Access Compliance Report

Public Rights-of-Way

(Curb Ramps)

Intersection ID: 48714	Main Street: SARDIS_CREEK_LN	Cross Street: KILCULLEN_DR	Location: W
ADA ID: DAF3D2FCAD25	Ramp Type: Perp	Initial Pass/Fail: Fail	Overall Compliance: No
Codes/Mitigation Info/Possible Solution		Field Measurements/Component Compliance	
Severity Score: 13.75

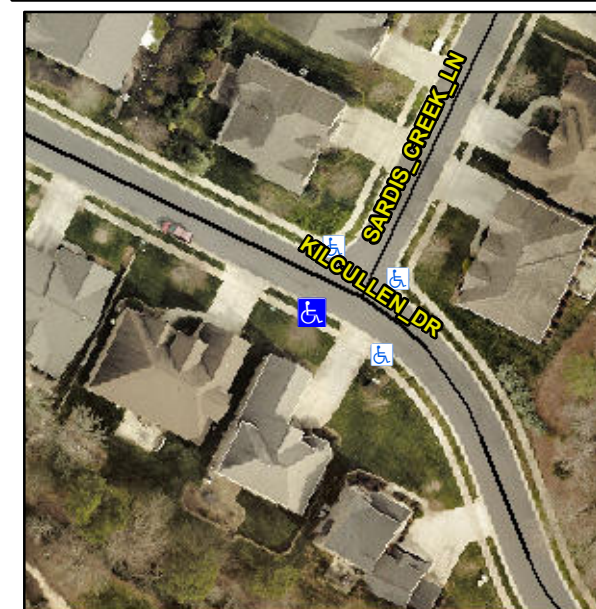
Surveyor Notes:

N/A

Compliance	Description	Data	Compliance	Description	Data
N/A	Ramp Length (in)	49.0	No	Ramp Slope (%)	9.0
Yes	Ramp Width (in)	48.0	Yes	Ramp XSlope (%)	3.5
N/A	Flare Type LT	N/A	N/A	Flare Type RT	N/A
N/A	Flare Slope LT (%)	N/A	N/A	Flare Slope RT (%)	N/A
N/A	Flare Traversable LT?	N/A	N/A	Flare Traversable RT?	N/A
N/A	Landing Length (in)	N/A	N/A	DWS Provided?	N/A
N/A	Landing Width (in)	N/A	N/A	DWS Contrast?	N/A
N/A	Landing Slope (%)	N/A	N/A	DWS Length (in)	N/A
N/A	Landing X Slope (%)	N/A	N/A	DWS Full Width?	N/A
N/A	Landing Curb? (Y/N)	N/A	N/A	DWS Offset (in)	N/A
N/A	Shared Landing?	N/A			
N/A	Gutter Ponding?	N/A	N/A	Gutter Slope (%)	N/A
N/A	Gutter Lip Ht (in)	N/A	N/A	Gutter X Slope (%)	N/A
N/A	Painted X Walk1?	No	N/A	Painted X Walk2?	N/A
	X Walk 1 Direction	To N		X Walk 2 Direction	N/A
N/A	X Walk 1 Width (in)	N/A	N/A	X Walk 2 Width (in)	N/A
	X Walk 1 Slope (%)	0.1		X Walk 2 Slope (%)	N/A
	X Walk 1 X Slope (%)	4.1		X Walk 2 X Slope (%)	N/A

Remove & Replace Entire Ramp.

R304.2.2
